December 22, 2015

RE: Proposed Nagog Pond Water Treatment Plant, Acton, Massachusetts  
Environmental Notification Form – Supplemental Submittal  
EEA No: 15446

During the recent MEPA consultation session held on site last Friday, December 18, 2015 the applicant (Town of Concord, Public Works, Water/Sewer Division) notified the group in attendance of several minor project changes. In addition, supplemental information was requested based on comments and questions made during the meeting. A summary of the project changes and clarifications:

FOR PERMITTING  
Sheet No. **C-5**

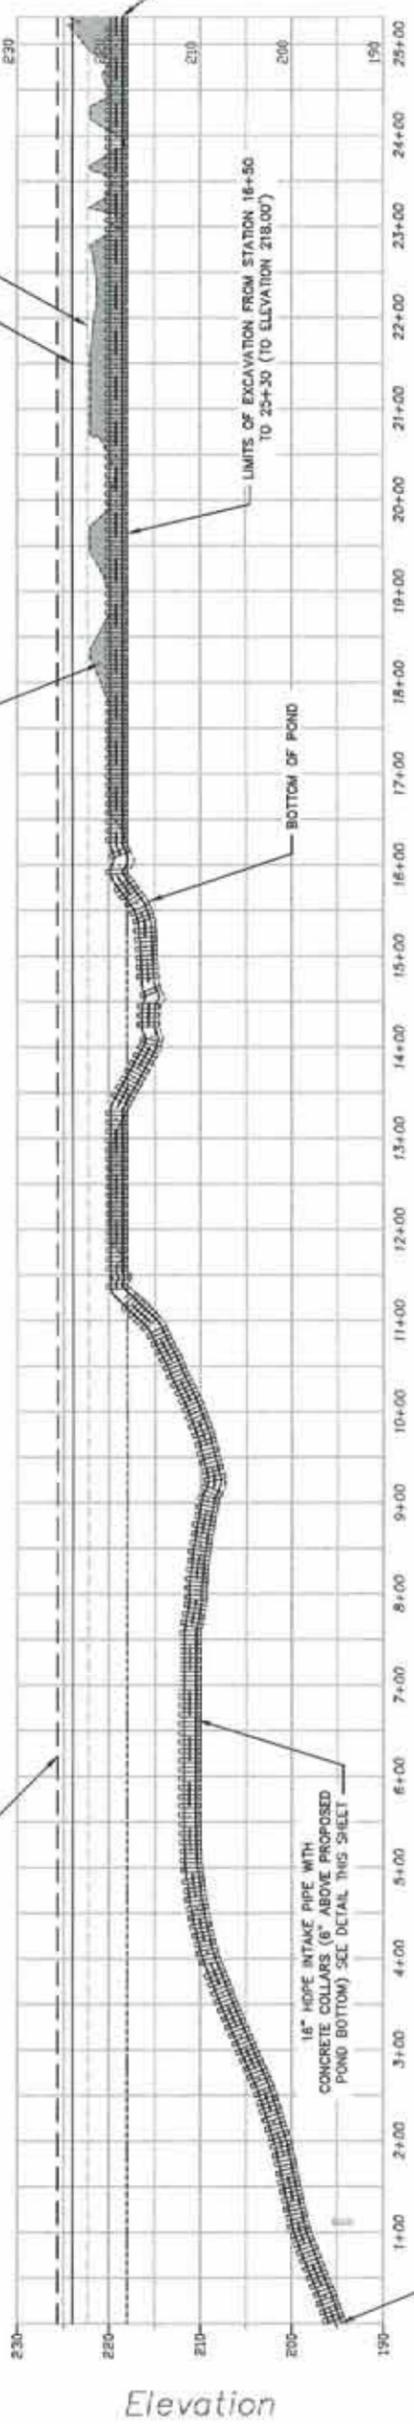
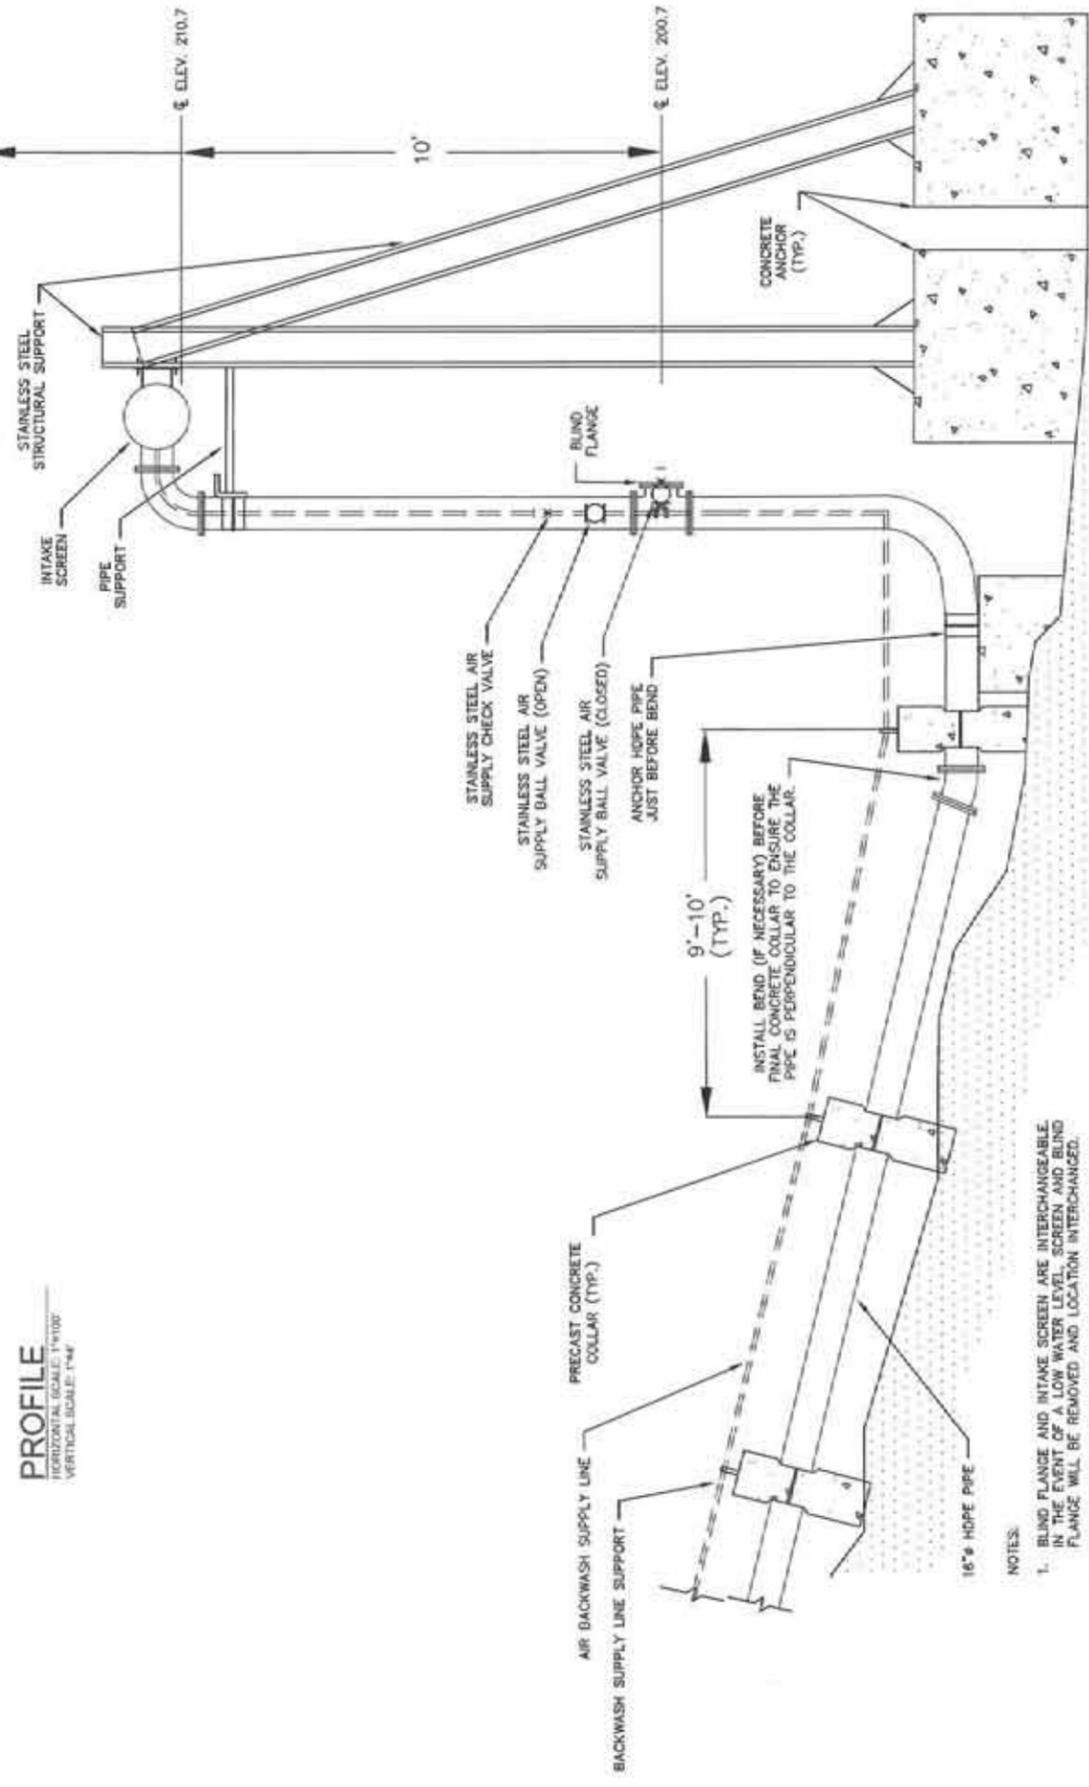
3. The proposed method of replacing the existing 16-inch intake line to Nagog Pond has been finalized and includes dewatering a section of Nagog Pond. The existing coffer dam which is partially submerged will be reconstituted and amended with the placement of a temporary coffer dam consisting of an impermeable barrier/liner and super sand sacks. Once the temporary coffer dam is in place, the existing Nagog Pond dam outlet structure will be utilized to dewater the lower section of the pond so that replacement of the intake pipe can be accomplished in the dry.

The area of the pond to be dewatered is shown on sheet C-5 (attached) and consists of approximately 707,019 square feet. This area also represents a volume of approximately 19.65 million gallons of water if the pond was full prior to dewatering. The target release rate of water to Nagog Brook is between 300 gallons per minute (gpm) and 700 gpm. If these release rates are achieved, the time for drawdown will be between 20 and 45 days. It is anticipated that construction activities associated with the intake, including draining

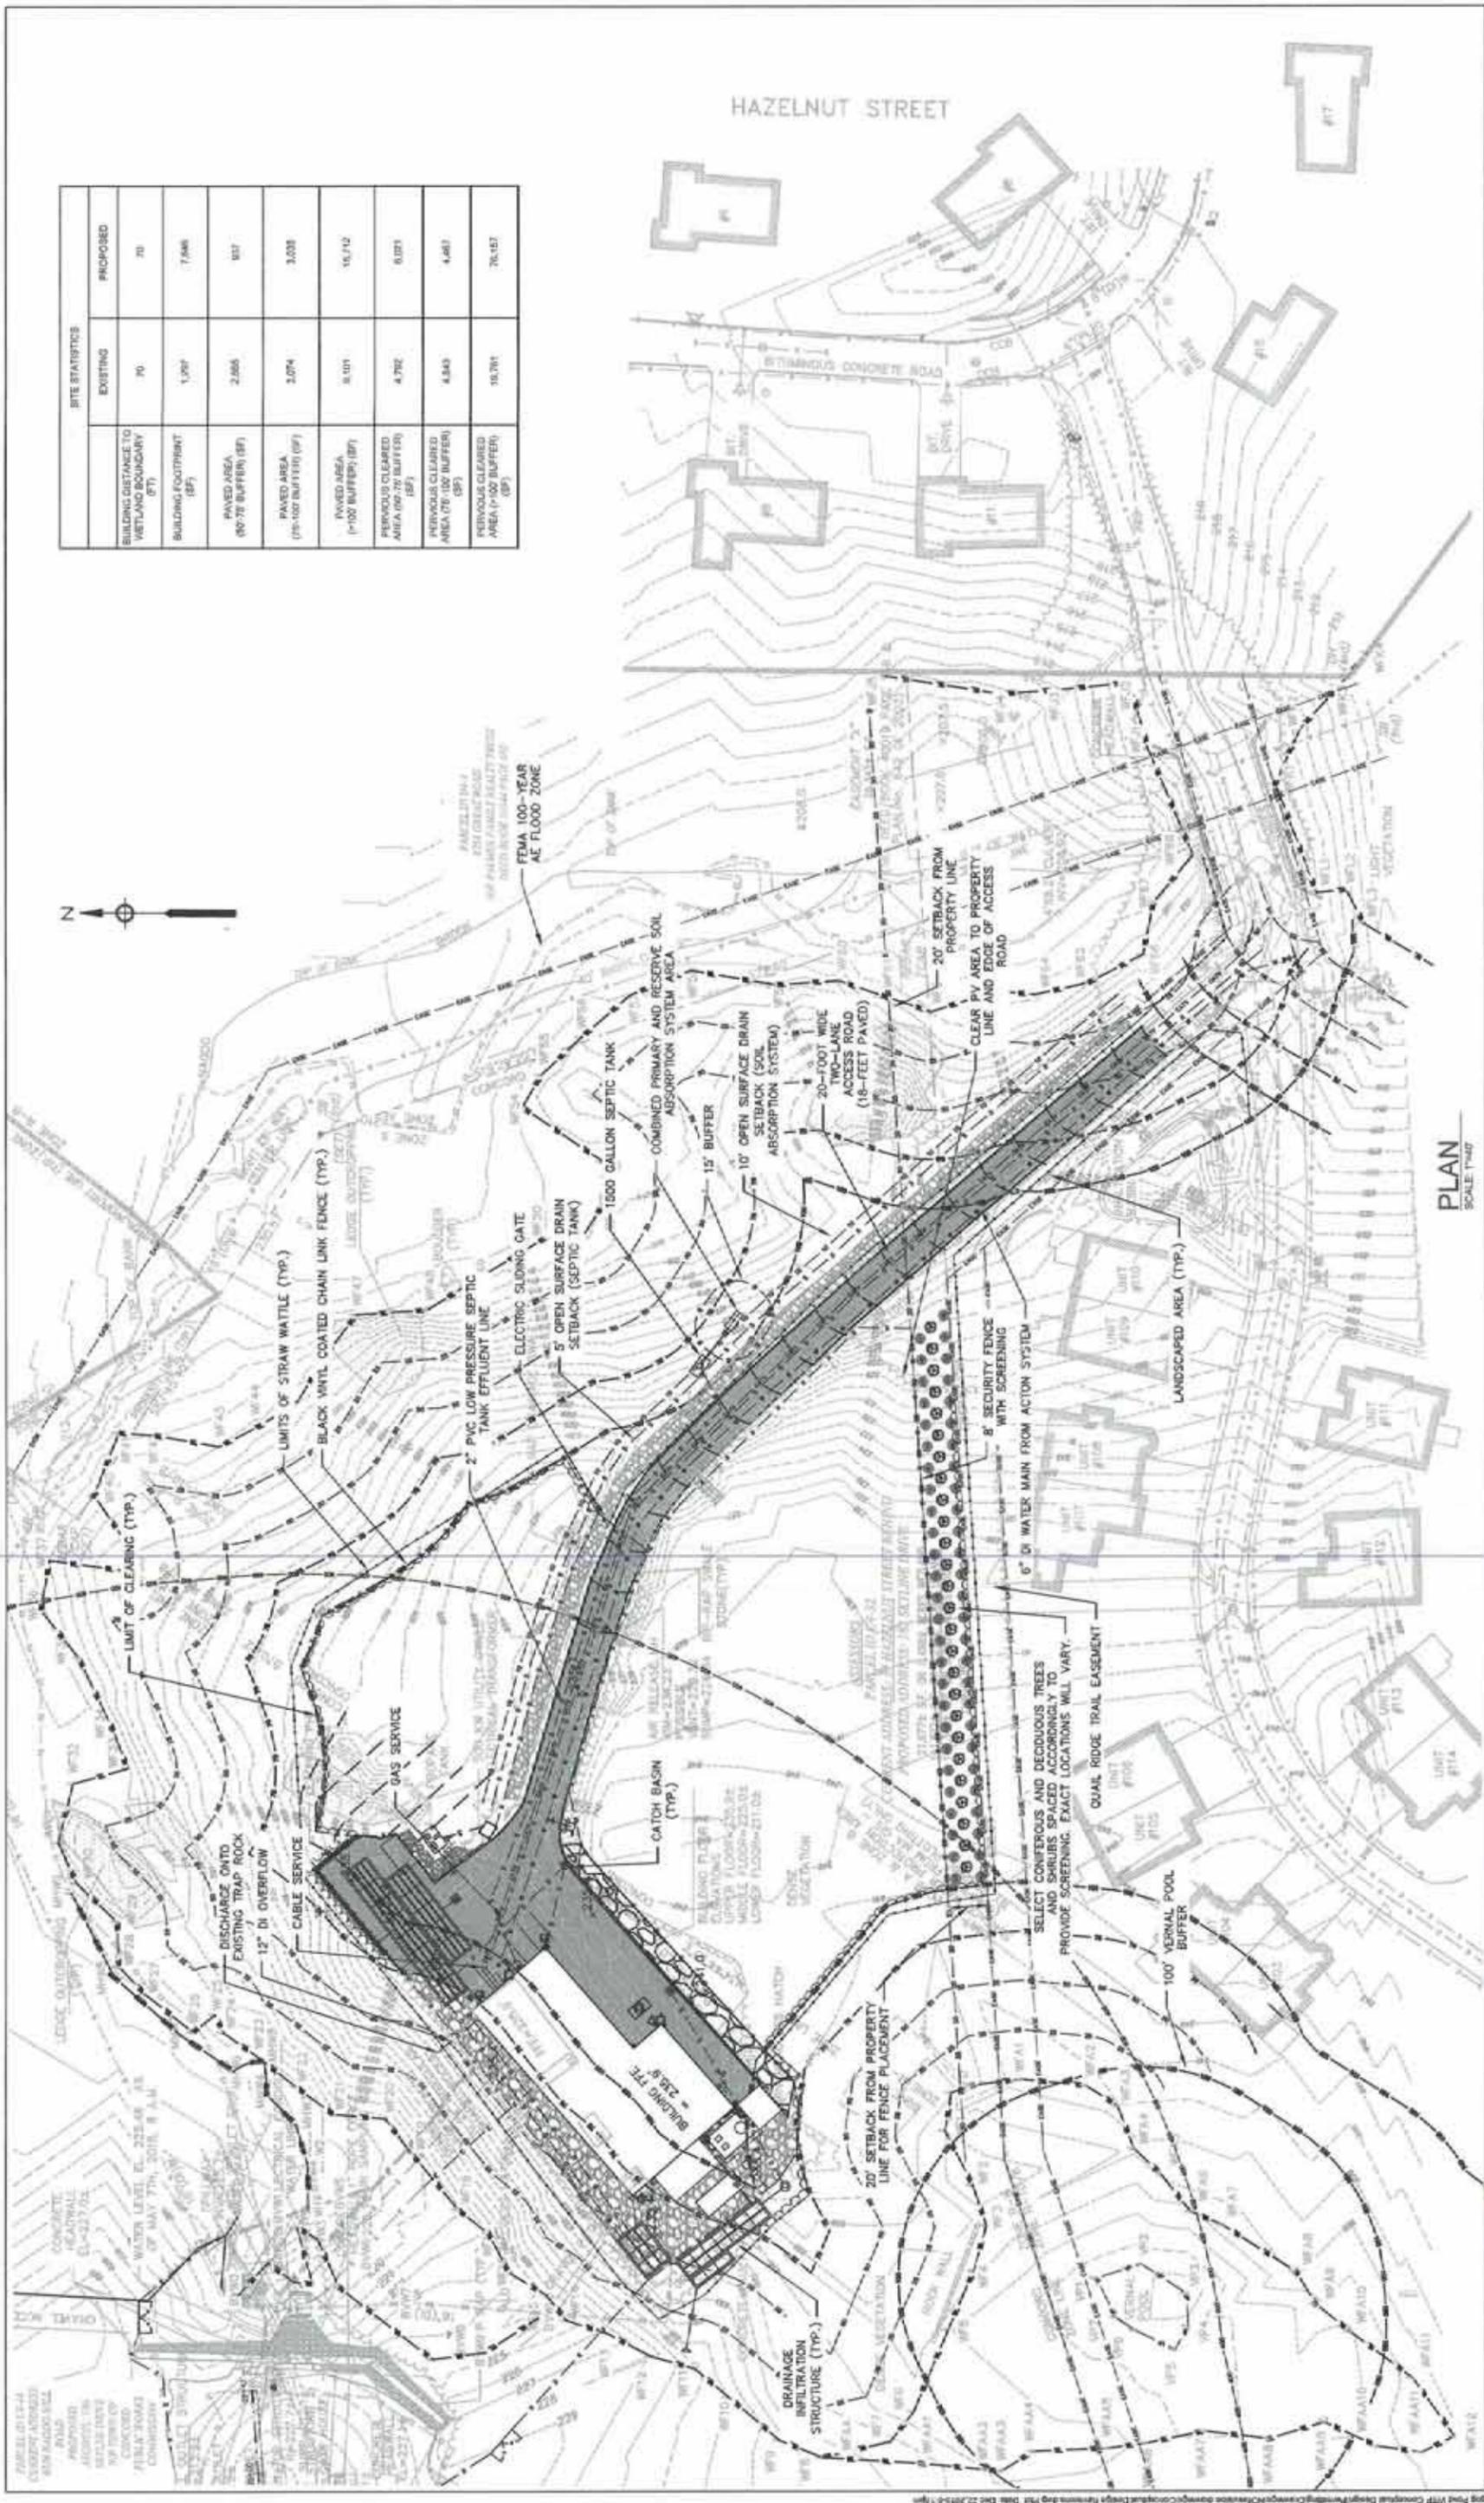
2. The proposed building has been shifted such that it is no closer to the wetland boundary than the existing building (70 feet). As such, the applicant has retracting its request for a waiver of the wetland by-law setback requirements. The footprint and floorplan of the WTP building has not changed. The location of the building has pivoted slightly on the northeast corner of the structure. Updated plans showing the new building location is attached (refer to Sheet C-9 and C-9S).

The revised plan Sheet C-9 includes a table of existing and proposed site features including clearing, pervious, and impervious areas. There are no proposed changes being made to the stormwater and drainage systems previously submitted. Based on the limited site changes proposed, it is anticipated that there will be negligible differences in stormwater management. As indicated by the previous stormwater analysis, it is expected that the peak stormwater discharge rates will be lower compared with existing conditions. An updated Stormwater Report has not been completed.

FOR PERMITTING  
Sheet No. **C-9S**

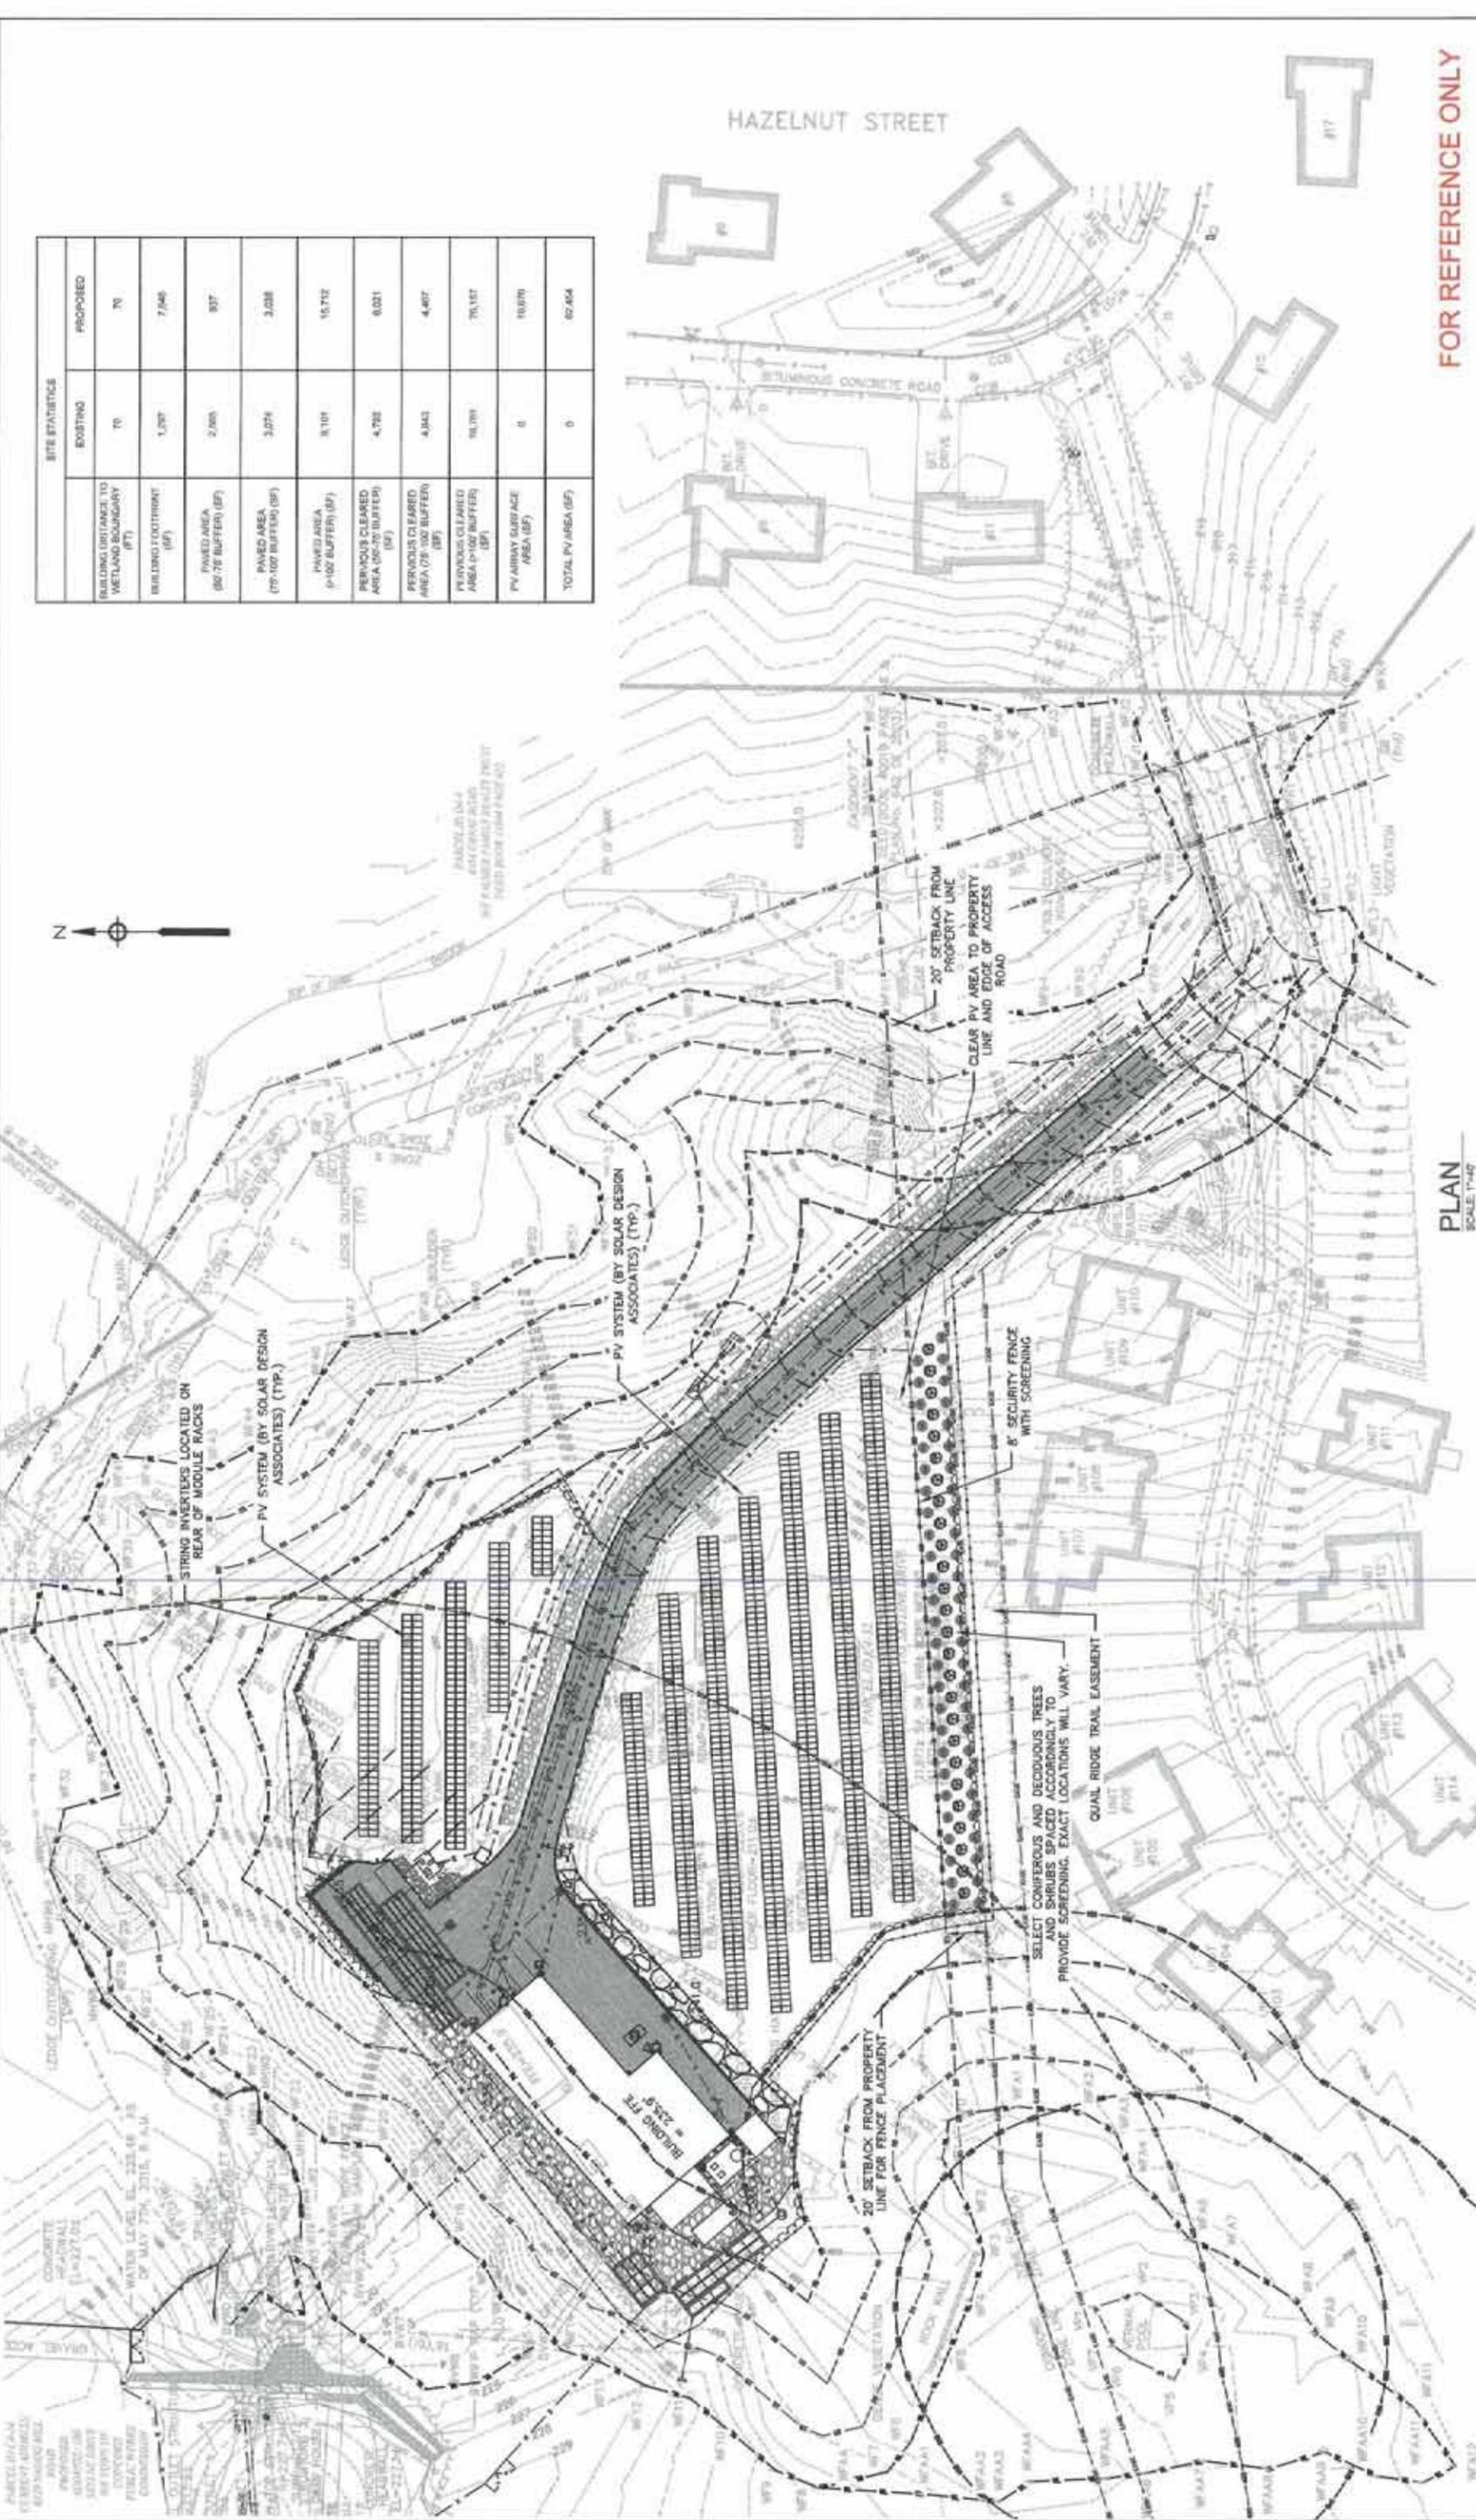
1. All activities associated with the proposed solar photovoltaic (PV) system, including clearing of land, have been moved outside the 100 foot wetland buffer. As such, the applicant has retracting its request for a waiver as all work associated with the proposed PV system is now outside the jurisdiction of the Conservation Commission. An updated plan showing the revised location of the PV system is attached (refer to Sheet C-9S).
